To: Saint Paul City Council
From: George Gause, Heritage Preservation Supervisor
Re: Appeal of HPC approval of ADU at 525 Holly

Re: Appeal on COA for an ADU at 525 Holly Ave

View through Holly park of house and existing garage in green. ADU will be taller, extended to left 5' and have deck over 9' off ground.

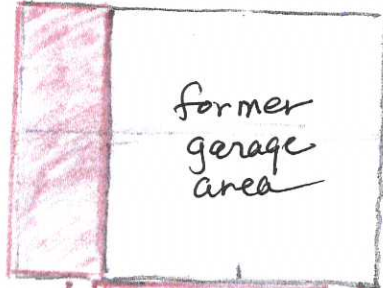
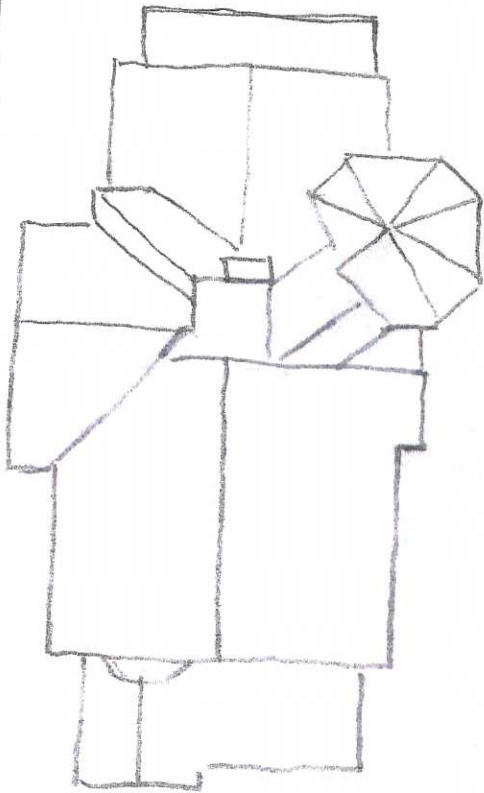
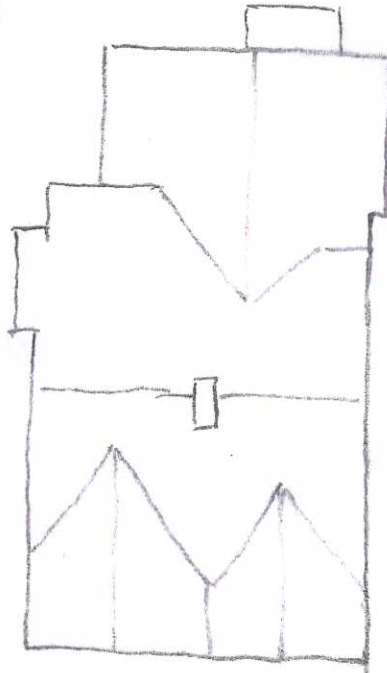
Code Section 74.65b Contrary to this new construction guideline, the ADU's design does not conform well to our adjacent back yard or to the neighborhood due to its **much greater relative scale compared to other neighboring structures**. Although the ADU is taller, but within the allowed height limit, it still has an impact. The increased wall height, in conjunction with the proposed 7 foot westward ADU extension toward the 529 property line and its fence, brings a taller wall within 3 feet of 529, creating a sense of enclosure and definitely affecting 529's back yard economic uses. Given that the ADU can be fully seen from Holly and there are 15 feet to the east for ADU extension, an eastward extension would diminish impact to important 529 back yard uses.

Pertaining to **Code Section 74.65b**, there was no mention or discussion that the proposed ADU's design totals an imposing 914 SF mass compared to the current structure's 576 SF. This is within the allowable SF back yard limit, but this 58.6% increase in 525's backyard physical infrastructure imposes on neighboring 529 Holly, which has three times less built structure in its backyard (see comparative illustration later).

The appellant has cited §74.65(b) Massing and Height. This section discusses 'residential structures' and gives an acceptable height range from 25 to 40 feet high. Clearly this was not intended for accessory structures. The massing and height are needed for the ADU. This area of the neighborhood contains several large, multi-stall accessory structures. The garage across the alley is 3 double stalls which is approximately 960 square feet in coverage. The ADU will add responsible density to this neighborhood and be in conformance with the Saint Paul Comprehensive Plan.
